September 21, 1973

SAFETY EVALUATION REPORT
BY THE
DIRECTORATE OF LICENSING
U.S. ATOMIC ENERGY COMMISSION
IN THE MATTER OF
CONSOLIDATED EDISON COMPANY OF NEW YORK, INC.
INDIAN POINT NUCLEAR GENERATING UNIT NO. 3
DOCKET NO. 50-286

AUXILIARY PUMP ROOM
FIGURE 6-4

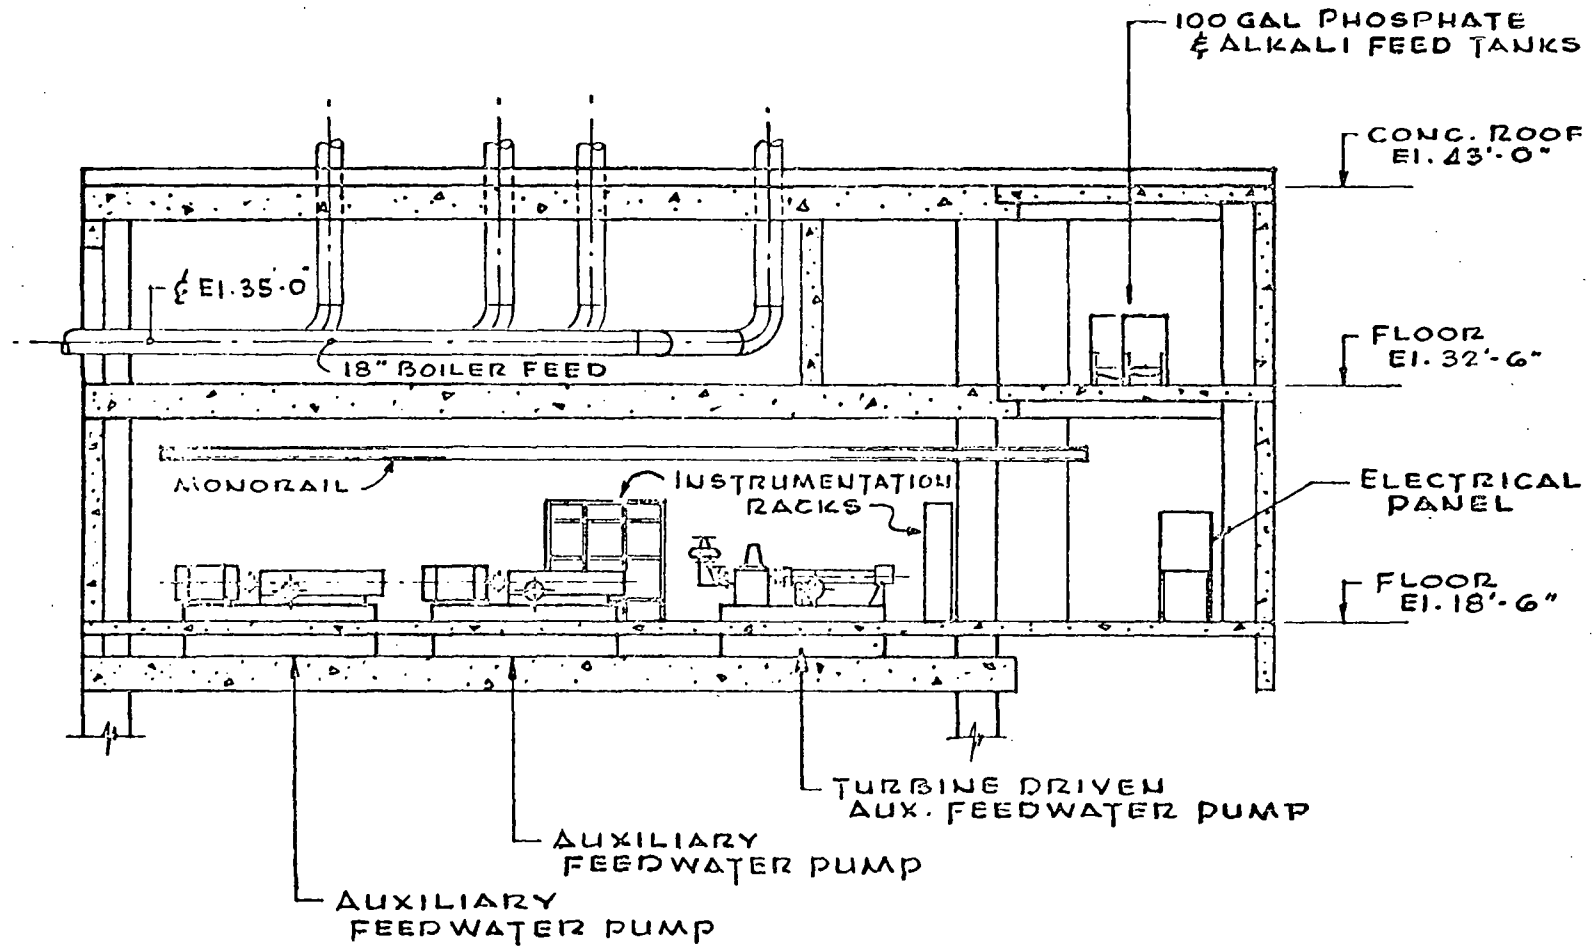
The auxiliary feedwater system removes heat from the secondary system whenever there is a loss of normal feedwater. Normal feedwater can be lost by pipe breaks, pump failures, valve malfunctions, or loss of offsite power. The auxiliary feedwater system also influences the fuel cladding peak temperature following a small break in the primary coolant system.

Auxiliary feedwater is supplied by two motor-driven auxiliary feedwater pumps and one steam turbine-driven auxiliary pump. Each motor-driven pump will deliver 400 gpm (at a head of 3200 feet) and the

steam turbine-driven pump will supply 800 gpm (at a head of 3300 feet).

FIGURE 10.1
ELEVATION VIEW
SHIELD WALL REGION

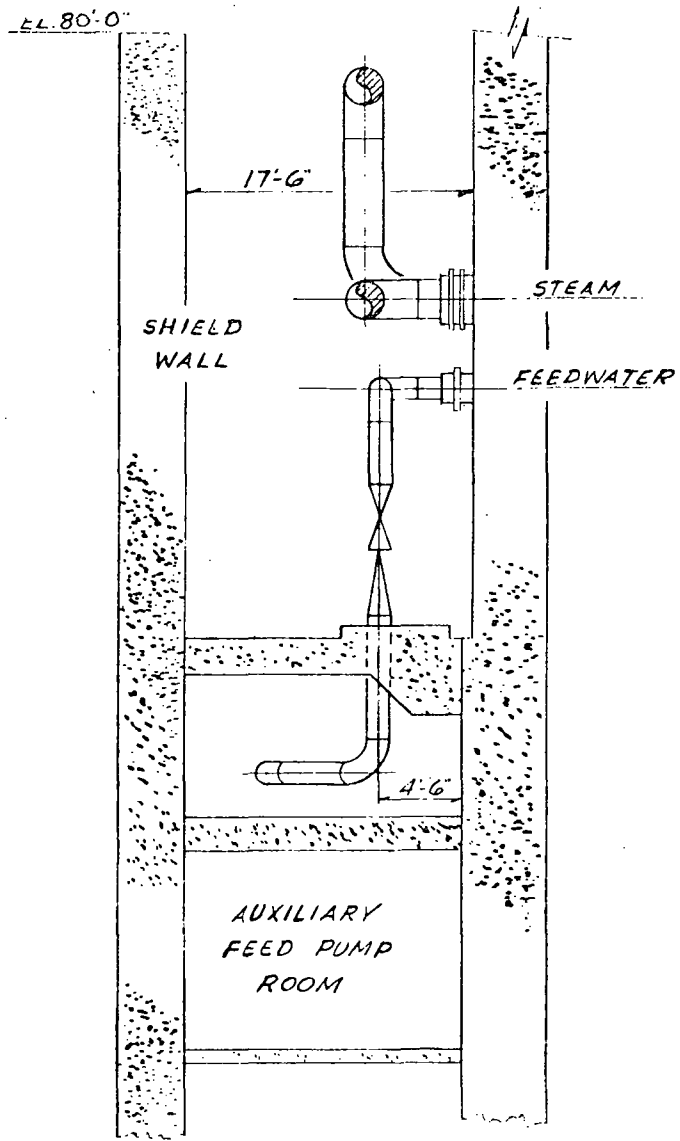
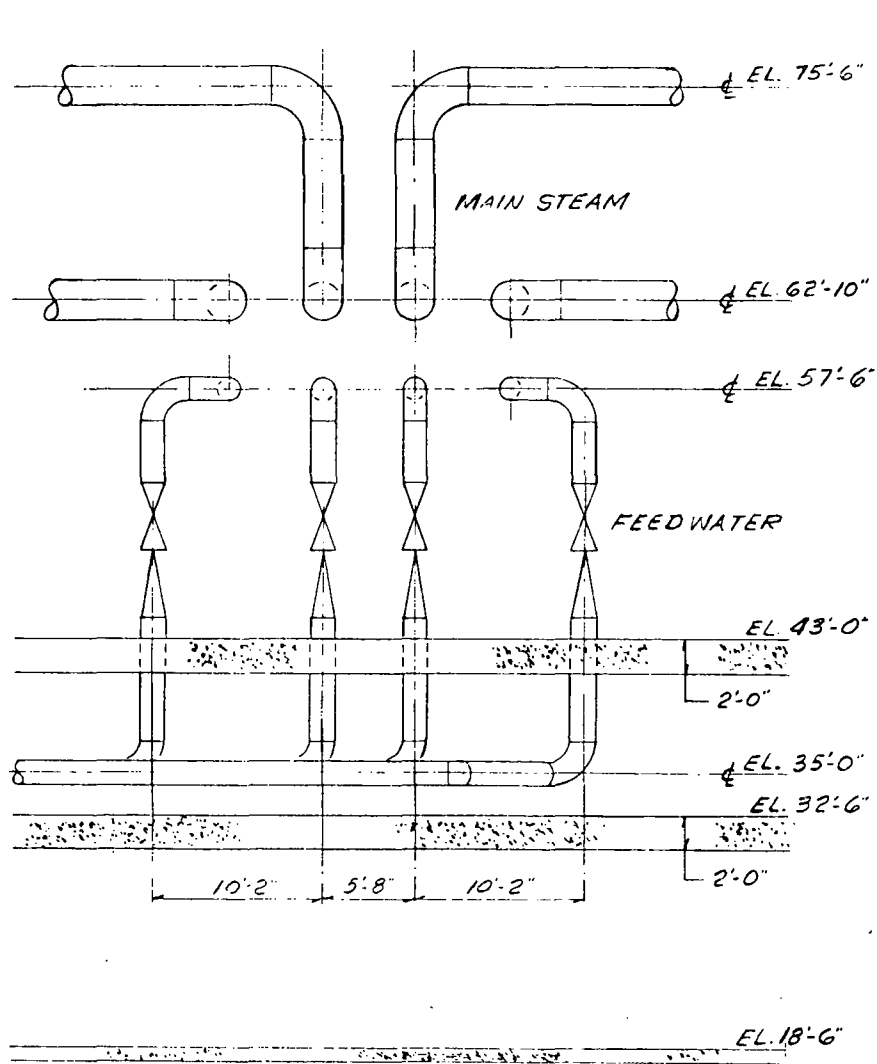
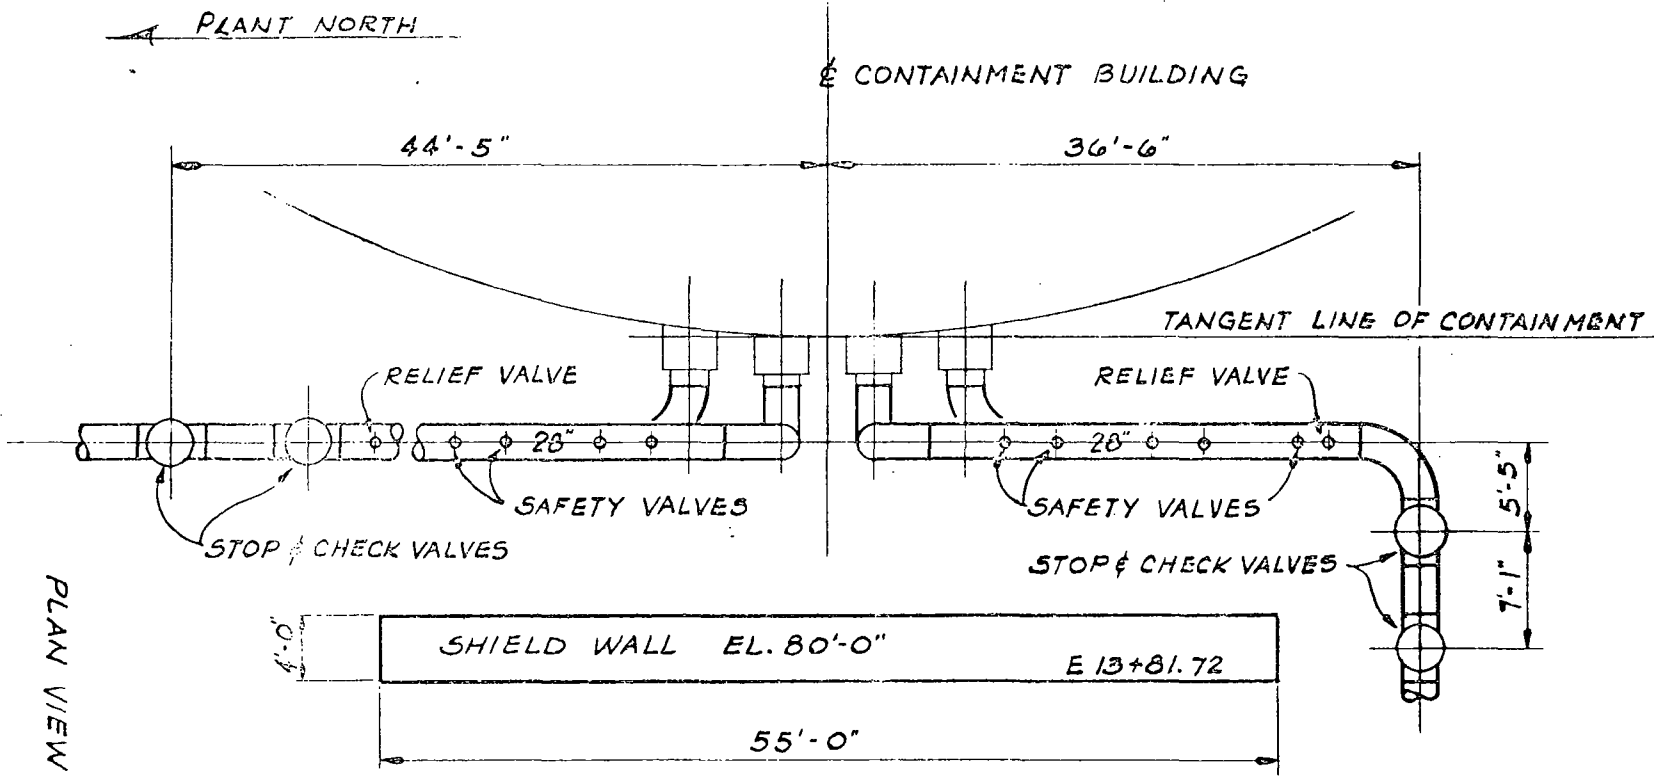
The possible effects of pipe whip, impingement, or high pressure and temperatures resulting from a postulated failure of any of the smaller high energy lines were investigated for the Control Building, the Diesel Generator Building, the Fuel Storage Building, the Turbine Building, and the Primary Auxiliary Building (PAB). Only the PAB required design modifications. The Control Room has essentially no high energy lines and the Diesel Generator Building's only high energy lines are the starting air lines whose failure would not damage Class I equipment. The Fuel Storage Building contains some auxiliary steam lines whose failure would not result in damage to the spent fuel pit. Failures of steam or feedwater lines within the Turbine Building will not prevent safe shutdown and will not cause the destruction of this large, highly ventilated building. Approximately 75 feet separate the nearest high energy line in the Turbine Building and the Control Building. This distance eliminates any concern about pipe whip and jet effects were found to produce negligible loads on the Control Building.

Design modifications that have been required as a result of the review of the smaller high energy lines include the addition of pipe restraints to portions of the steam generator blowdown lines, shielding around cable trays to eliminate jet impingement effects and an alarm system to prevent overheating of the penetration area because of a ruptured letdown line, steam generator blowdown line,
